## REVISED RESPONSE TO REQUEST FOR ADDITIONAL INFORMATION

### APR1400 Design Certification

Docket No. 52-046

**RAI No.:** 301-8280  
**SRP Section:** 07.01 – Instrumentation and Controls  
**Application Section:** 07.01  
**Date of RAI Issue:** 11/10/2015

Figure 1. Probability Density Function (PDF) for Fq Modeling Errors

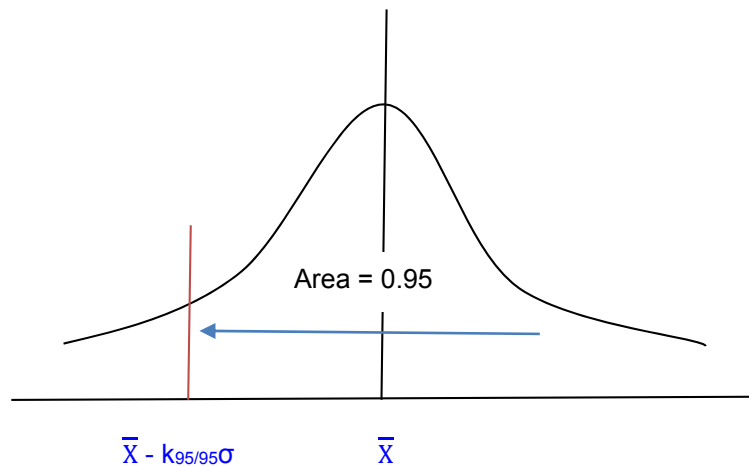
Discuss how using one-sided tolerance limit factor is consistent with Regulatory Guide 1.105, "Setpoints for Safety-Related Instrumentation," Revision 3.

Section 2.1.3, "LPD LSSS statistical methods," of the CPC Setpoint Analysis Methodology Technical Report, states for Equations 2.3 and 2.5 state a normal distribution confidence coefficient of 1.645 for 95% confidence. It is not clear to the staff why these coefficients are consistent with the 95/95 tolerance limit discussion in Regulatory Guide 1.105, Rev. 3, which the staff interprets the limit to correspond to an error distribution approximately equal to two sigma value, 1.96, and not 1.645 as stated in the Technical Report APR1400-F-C-NR-14001. Provide the basis for using this factor with respect to Regulatory Guide 1.105, Revision 3.

The overall uncertainty factor analyses for the core protection calculator (CPC) local power density (LPD) are performed by comparing the 3-D peaking factor (Fq) that is calculated by the reactor core simulator and the peaking factor that is calculated by the off-line CPC, as described in technical report (TeR) APR1400-F-C-NR-14001, Rev. 1, "CPC Setpoint Analysis Methodology for APR1400"

The Fq modeling error ( $X_F^i$ ) between the CPC synthesized Fq and the actual Fq is defined as follows:

Where ("SYN" Fq)<sup>i</sup> and ("ACTUAL" Fq)<sup>i</sup> are the CPC Fq and the reactor core simulator Fq for the i-th case. The Fq error is analyzed for each case at each time-in-life. Approximately 1200 cases are analyzed at each time-in-life (BOC, MOC, and EOC).

[The value of 1.645](#)

The value of 1.645 in the note of equation 2.5 is the 95/95 “one-sided tolerance limit factor” for infinite number of data points. In reality, the value of k is not 1.645 but rather depends on the sample size (N). In the description of the notes below equation 2.5, there is an editorial error. The description “(k= 1.645 for a 95/95 probability/confidence level and infinite” should be corrected as “... (k = 1.645 for a 95/95 probability/confidence level and infinite number of data points)”
